SB-10052017-4197

Title: TerraStar Transmission Shift Cable Routing

Applies To: Terrastar Trucks
DESCRIPTION

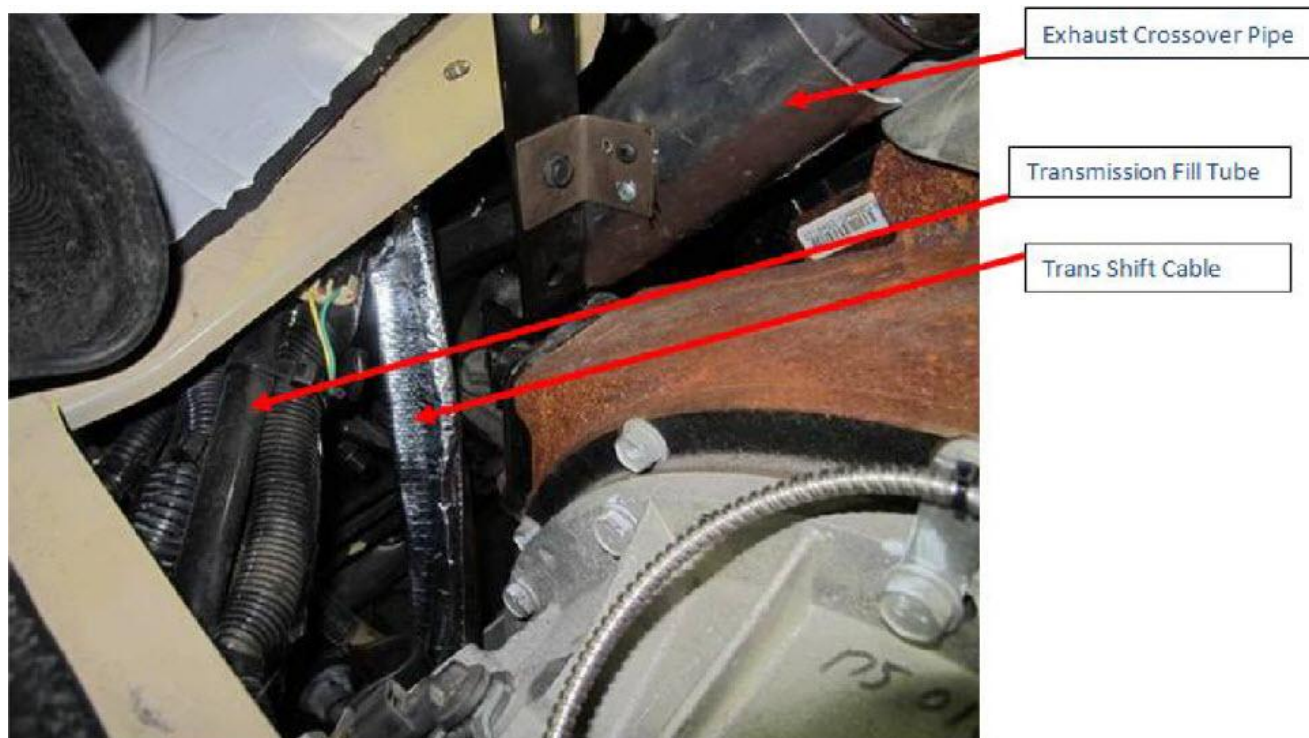
On 2010 through 2012 model year TerraStars, the shift cable may be routed incorrectly causing damage to the shift cable. This can cause difficulty selecting the desired transmission range, or if not resolved quickly, damage to the column gear shift assembly.

IDENTIFICATION

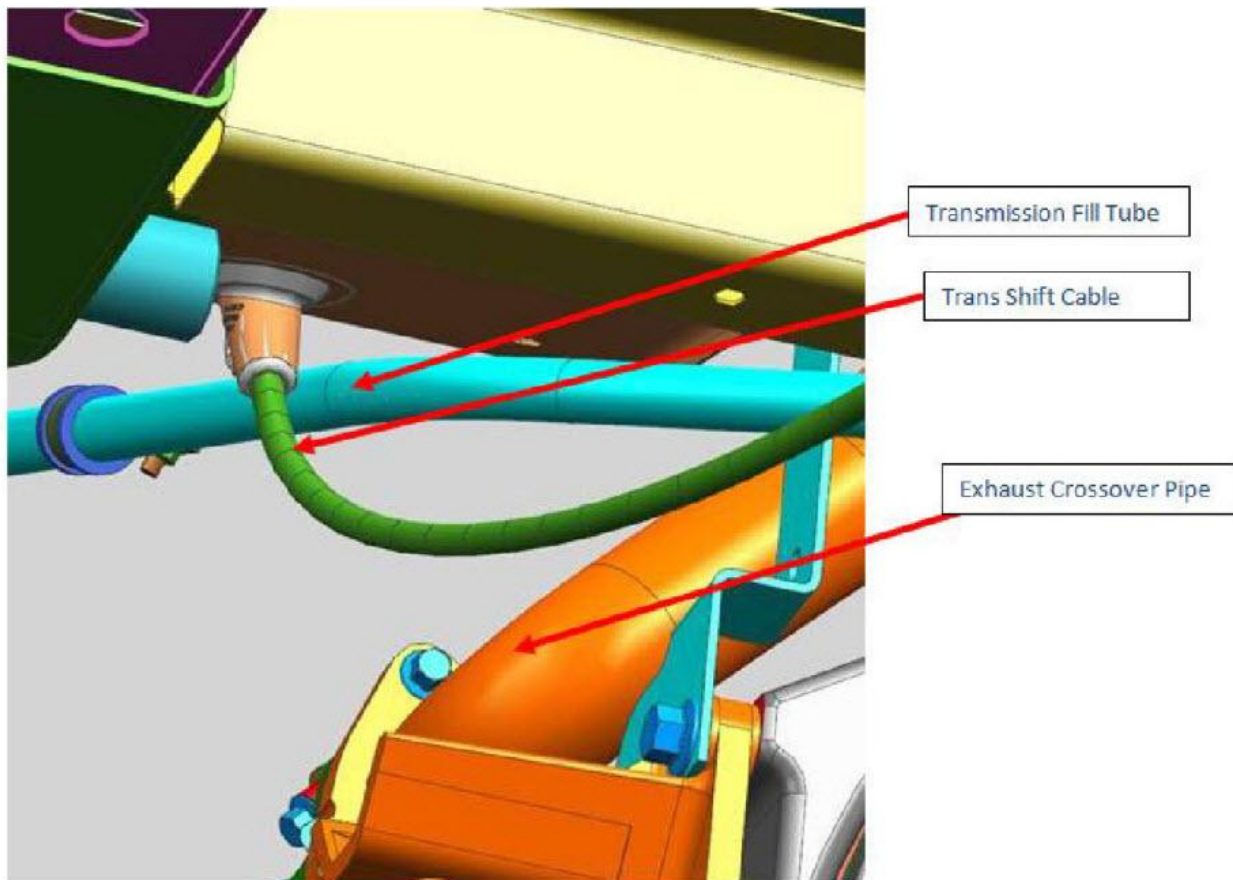
Applies to vehicles built with shift cable part number 2605843C1 and/or column shifter part number 2592668C91(0013WCP).

Incorrect Routing - Transmission shift cable is routed to the inside of the transmission fill tube.

Correct Routing - Transmission shift cable is routed to the outside of the transmission fill tube.
